ADDENDUM NO. 2

TO: PLANS AND SPECIFICATIONS FOR THE STATE OF MISSOURI

HVAC Improvements
Fulton Reception and Diagnostic Center
Fulton, Missouri
Project No.: C2406-01

E301.D

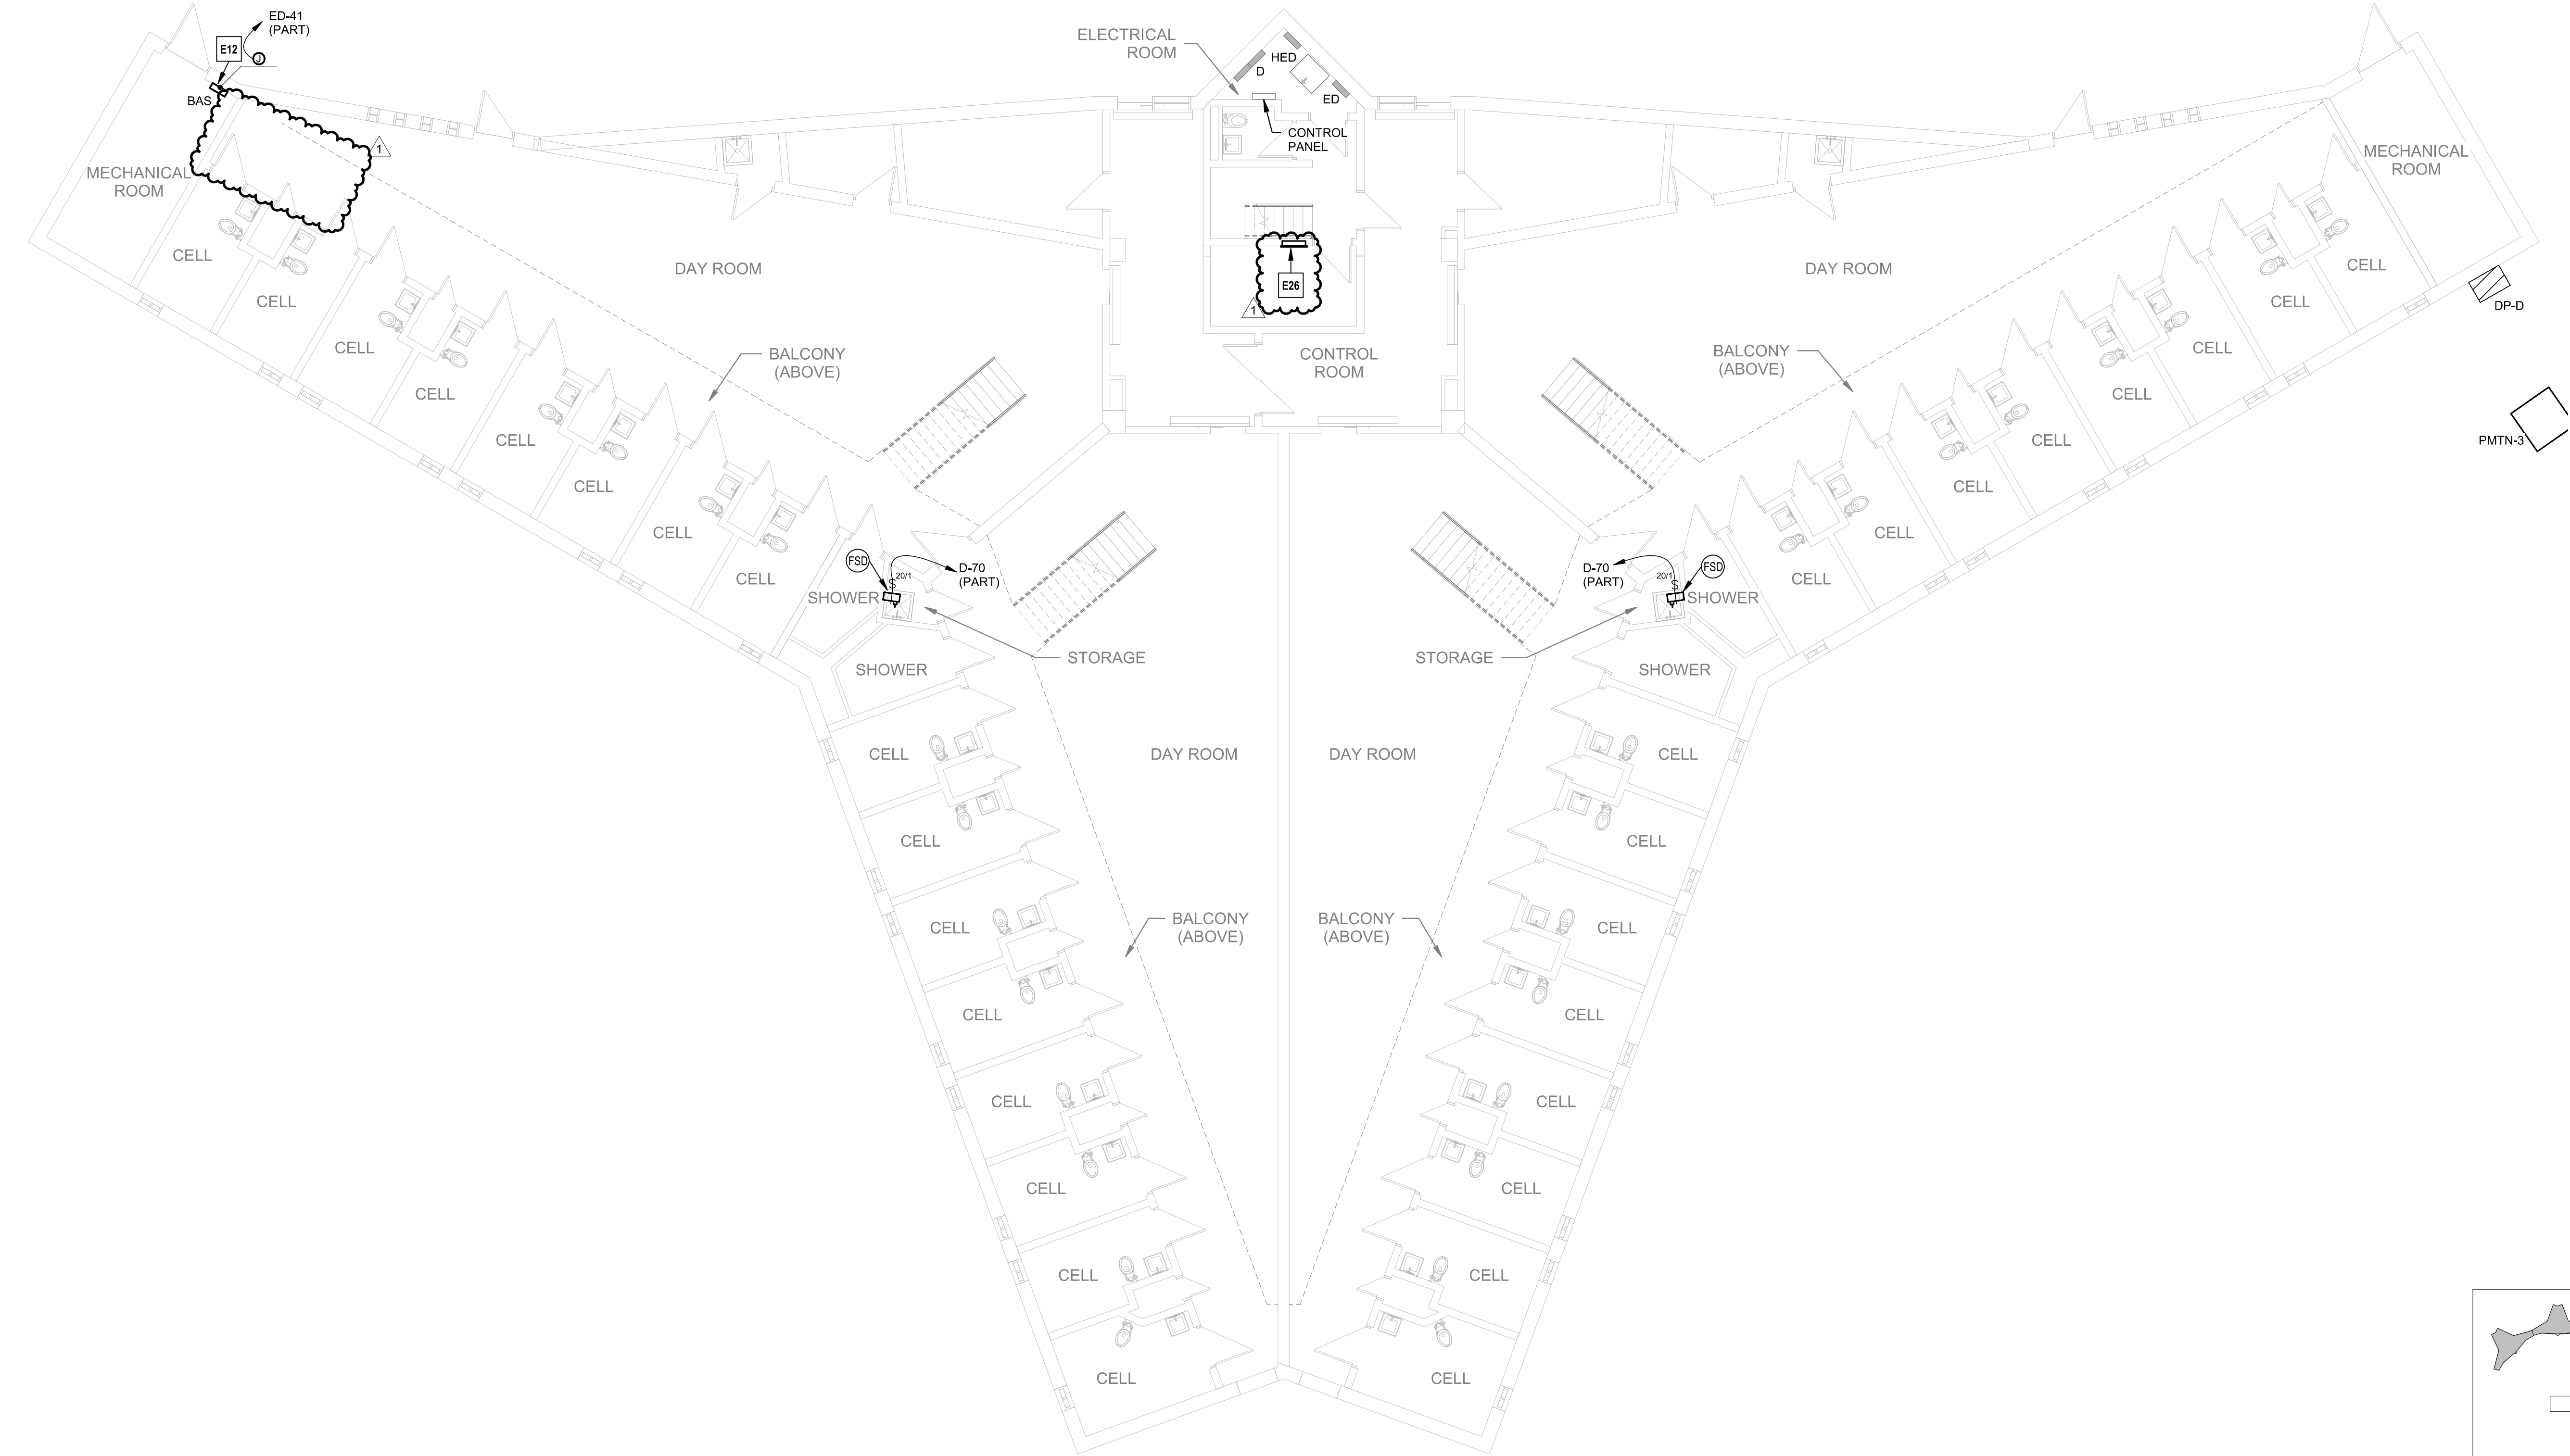
- 1) Equipment Connection - Bldg. D - typ. of Bldgs. E,F,G,&K:
 - a. Remove connection to firefighter control panel.
 - b. Add connection to replaced Fire Alarm Control Panel.

9. E301 Sheets Note E18 calls for fire fighter control panels. These are not shown anywhere else on the drawings. If they are part of the job who is providing and monitoring these.

Response: Drawing has been updated to remove reference to fire fighter control panels. Refer to attached revised drawing.

E301.L

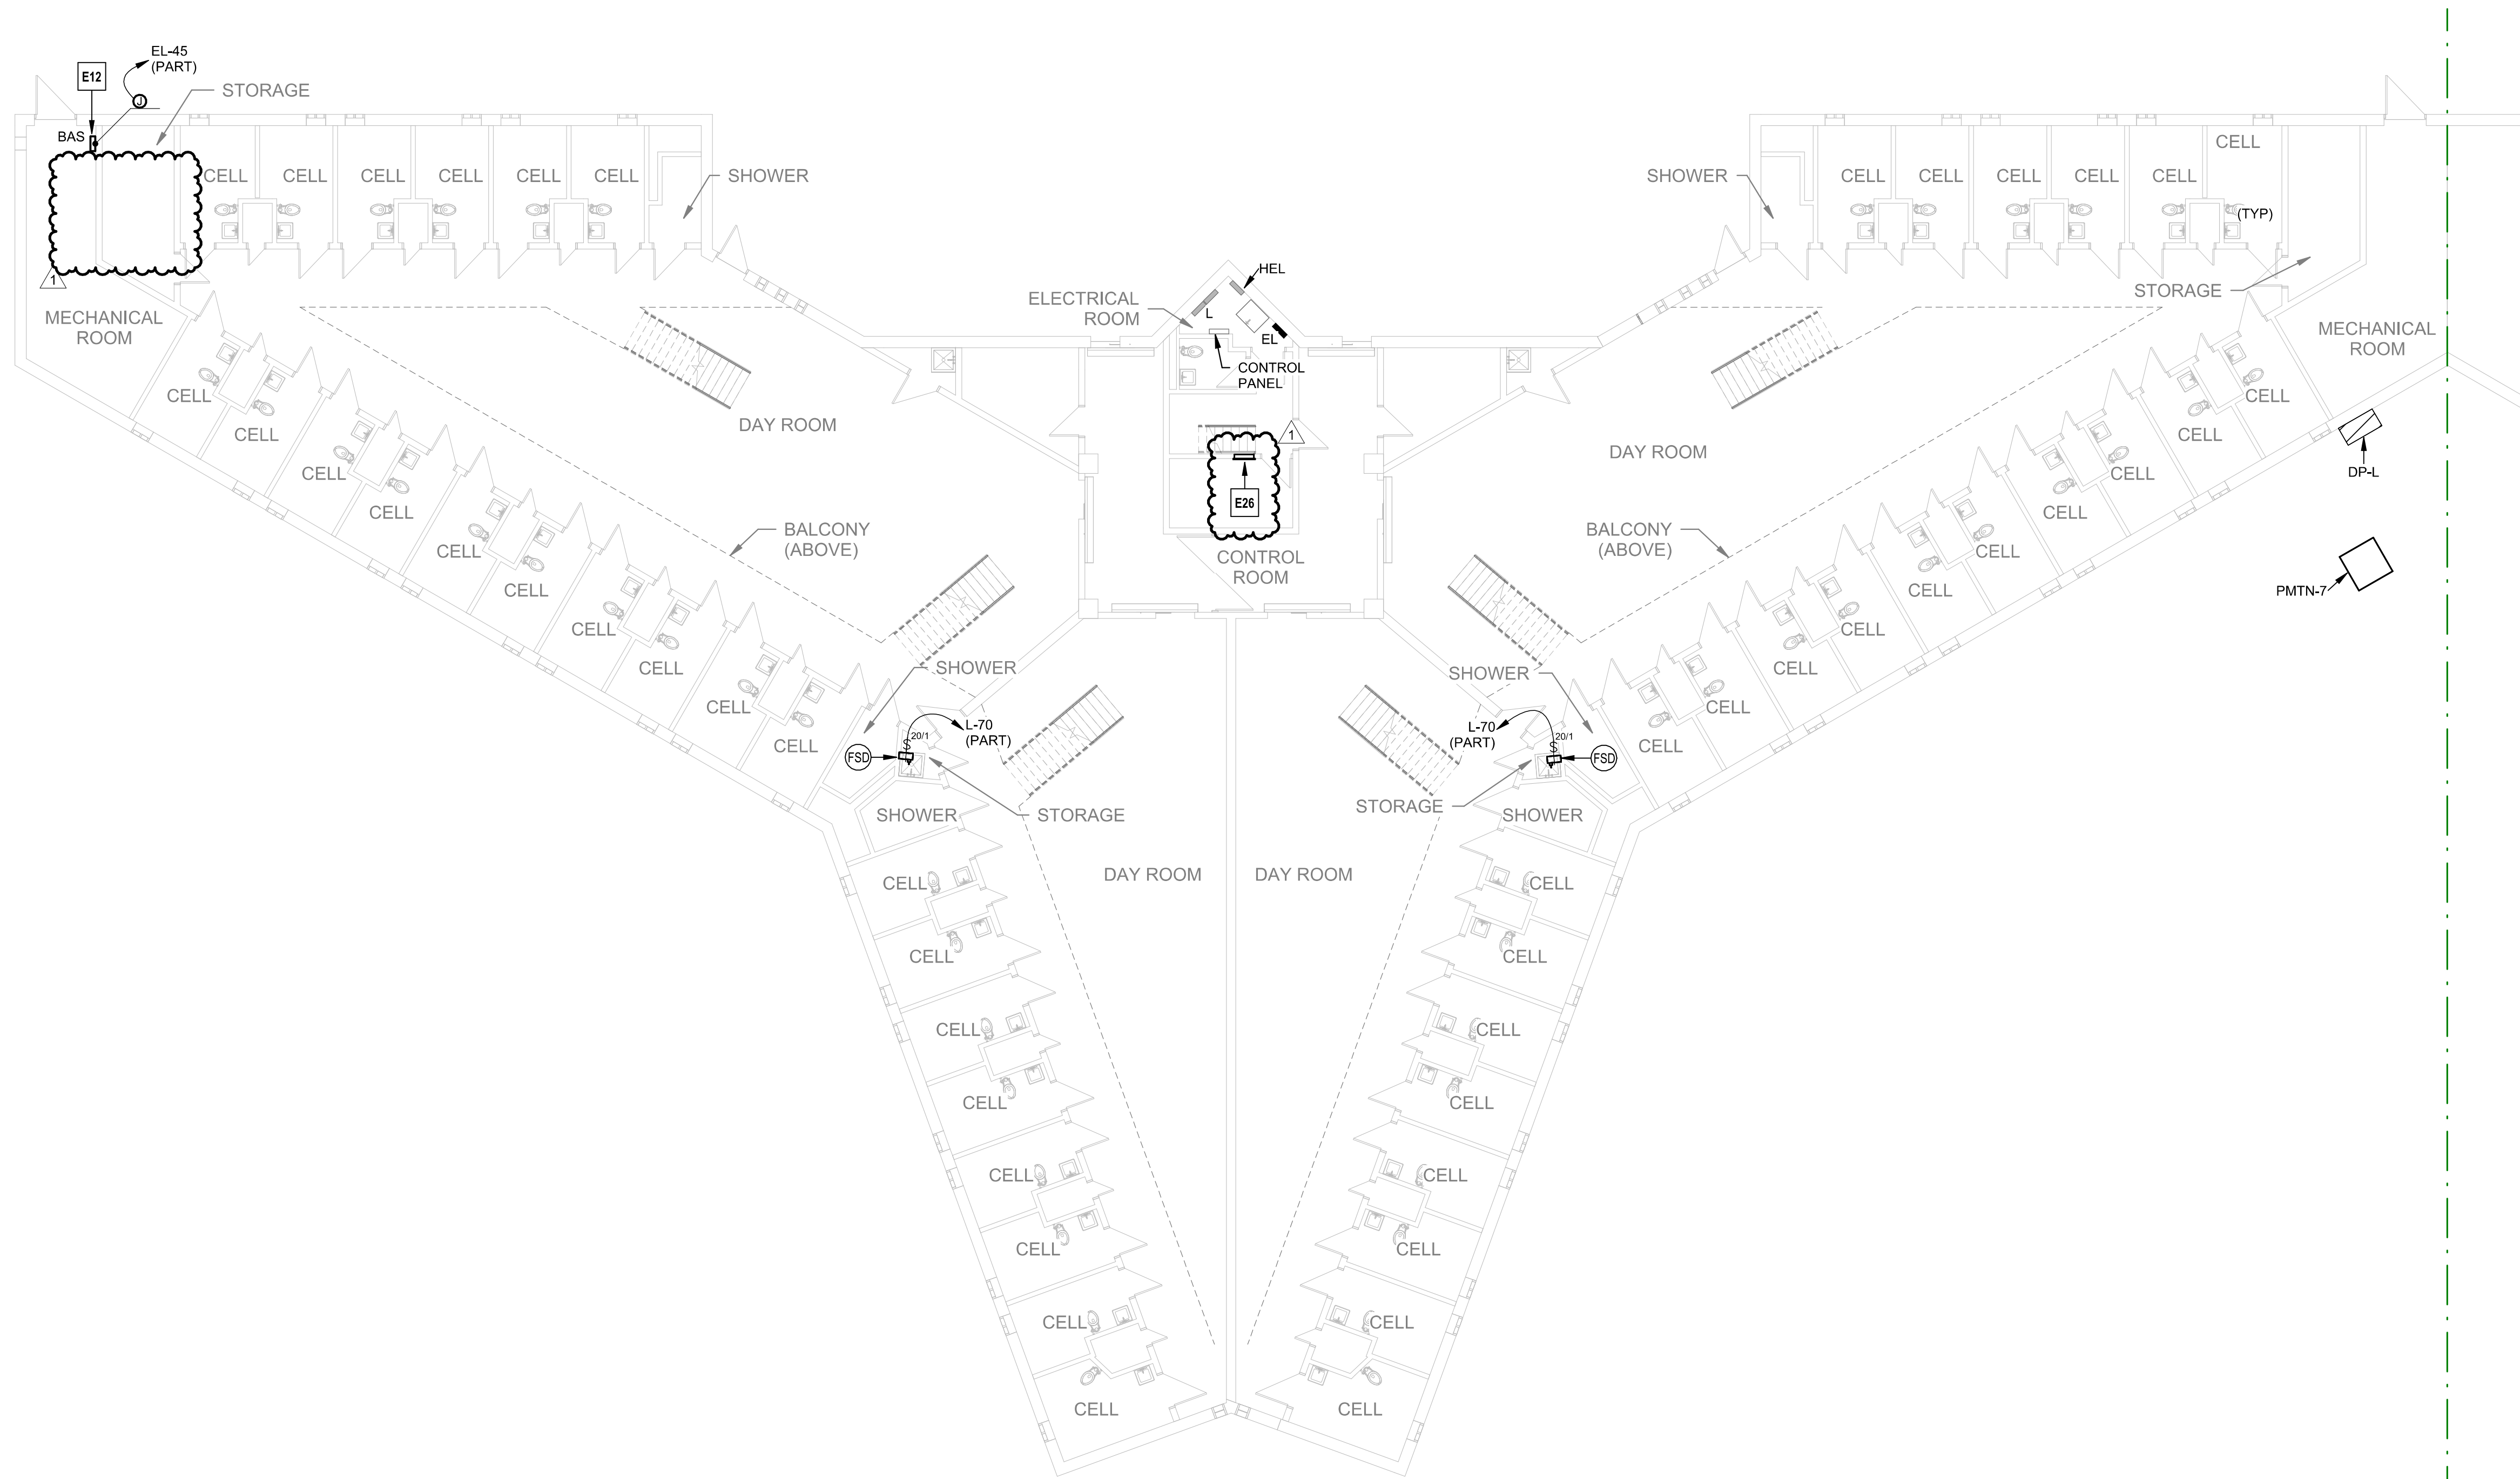
- 1) Equipment Connection - Bldg. L - typ. of Bldgs. M:
 - a. Remove connection to firefighter control panel.
 - b. Add connection to replaced Fire Alarm Control Panel.
